REFERENCE: Arborist Response to City Review Comments RE: SUB22-009 (Cui Preliminary Short Subdivision)

SITE ADDRESS: 4833 90th Ave SE, Mercer Island, WA

DATE: 12/6/2023

Figures 1 and 2. Tree #63 proximity to existing house and foundation (left). Location of proposed utilities and driveway (right).

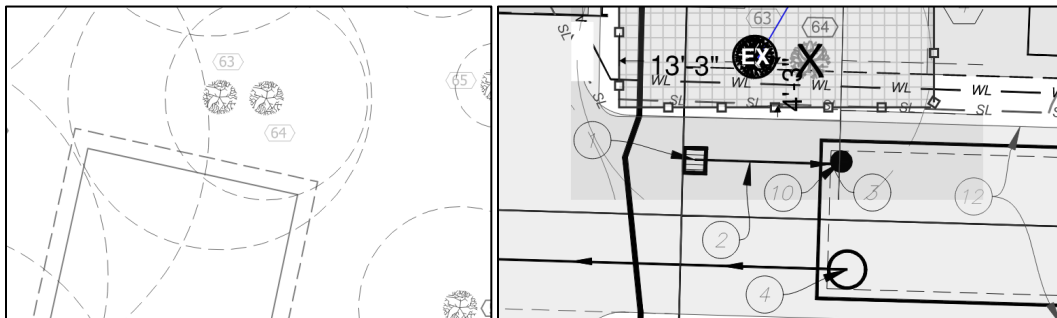
Lot 1 – House footprint was shifted west to edge of buildable area and house footprint was reduced to retain Exceptional tree #s 63 and 68. Tree #63 is a 25.2-inch DBH Pacific Madrone tree located in the southeast corner of proposed Lot 1. The tree is proposed to be protected at its dripline to the north and east; however, encroachment is proposed to the south to construct the access road, detention tank, and associated catch basin. This work will occur 6 to 10 feet from the tree trunk. The existing single-family home is located about 8-feet south from the trunk of this tree; therefore, it is not anticipated that impacts from this work will substantially impact tree #63.
